**GENOA CHARTER TOWNSHIP BOARD**

**May 2, 2016**

<b>Attention:</b>	Kelly Van Marter, AICP Assistant Township Manager and Planning Director
<b>Subject:</b>	Howell Medical Building – Site Plan Review #2
<b>Location:</b>	2765 E. Grand River Avenue – north side of Grand River, east of Meadowview Drive
<b>Zoning:</b>	GCD General Commercial District

**Re: Howell Medical Center  
Site Plan Review #2 Revised**

**SOUTH ELEVATION**  
1/8" = 1'-0"

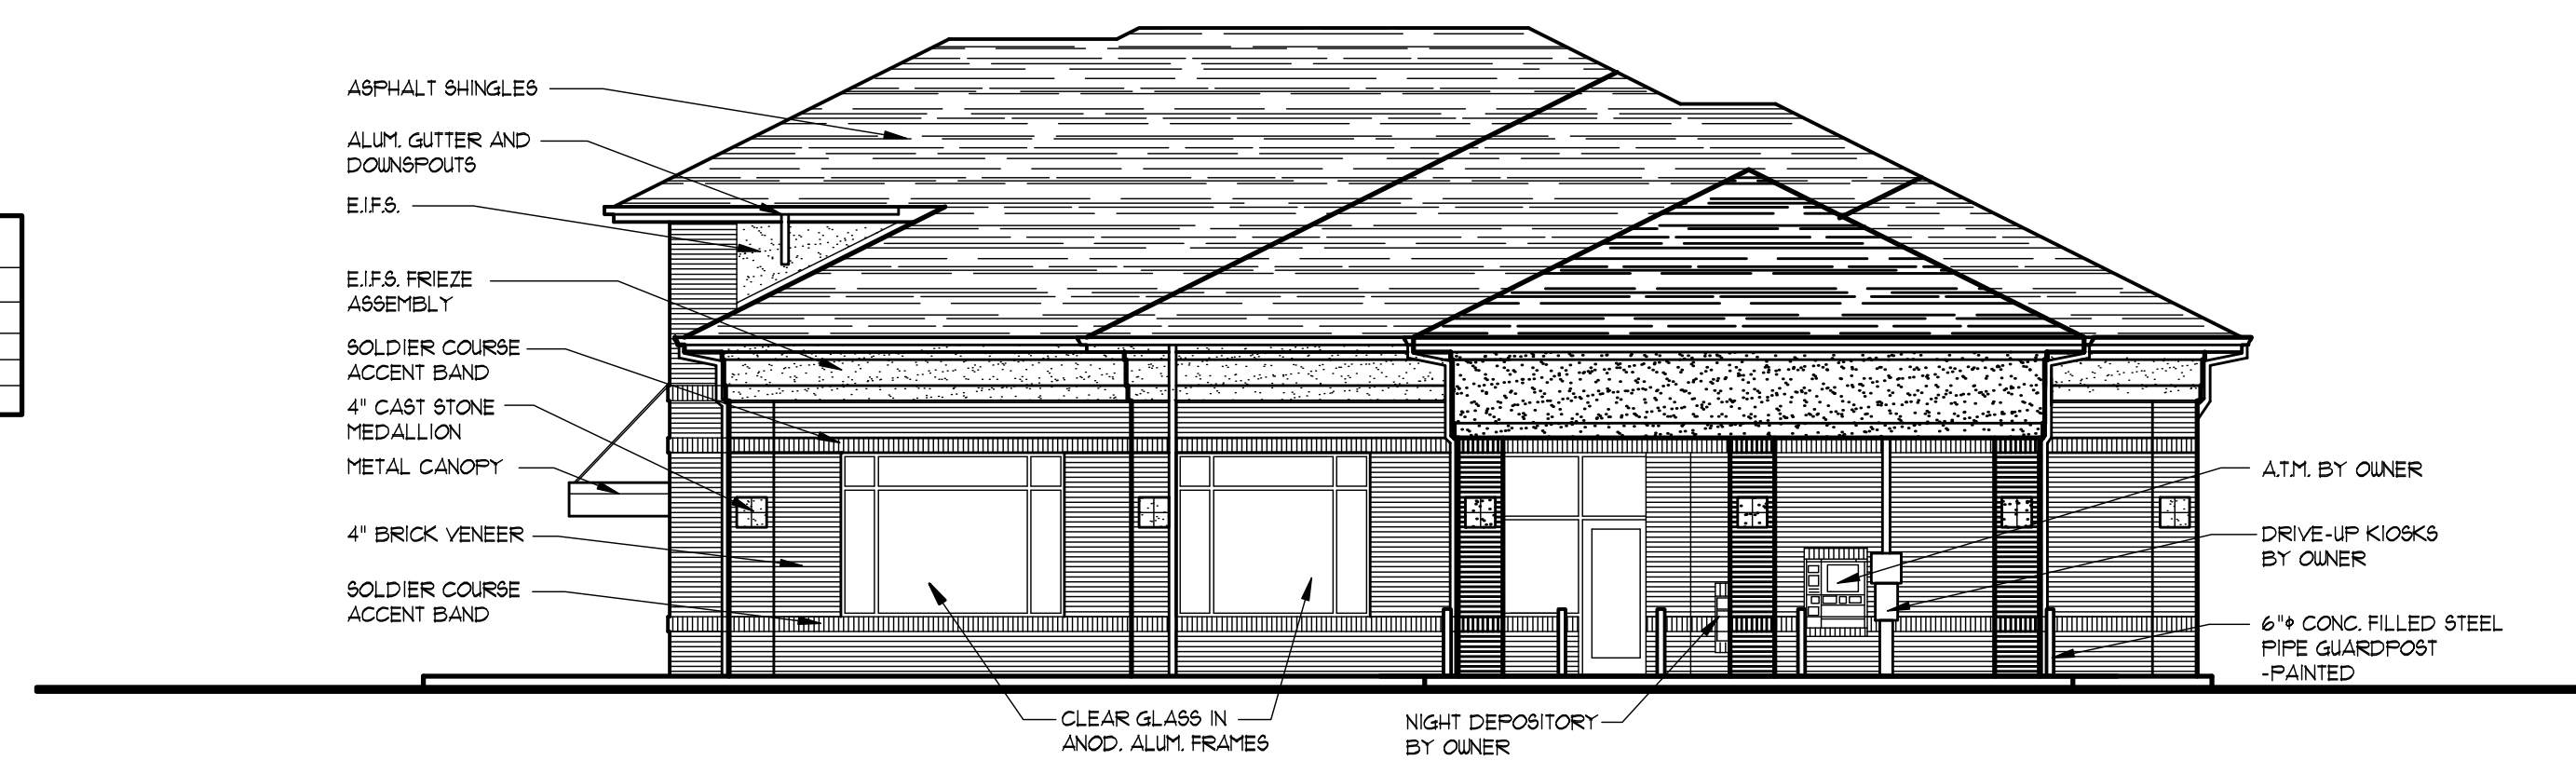
The PUD Agreement requires that each wall face contain at least 80% natural materials, such as brick or stone. Based on the calculations provided on Sheet A-2, the amount of EIFS slightly exceeds that permitted on the east and south building elevations.
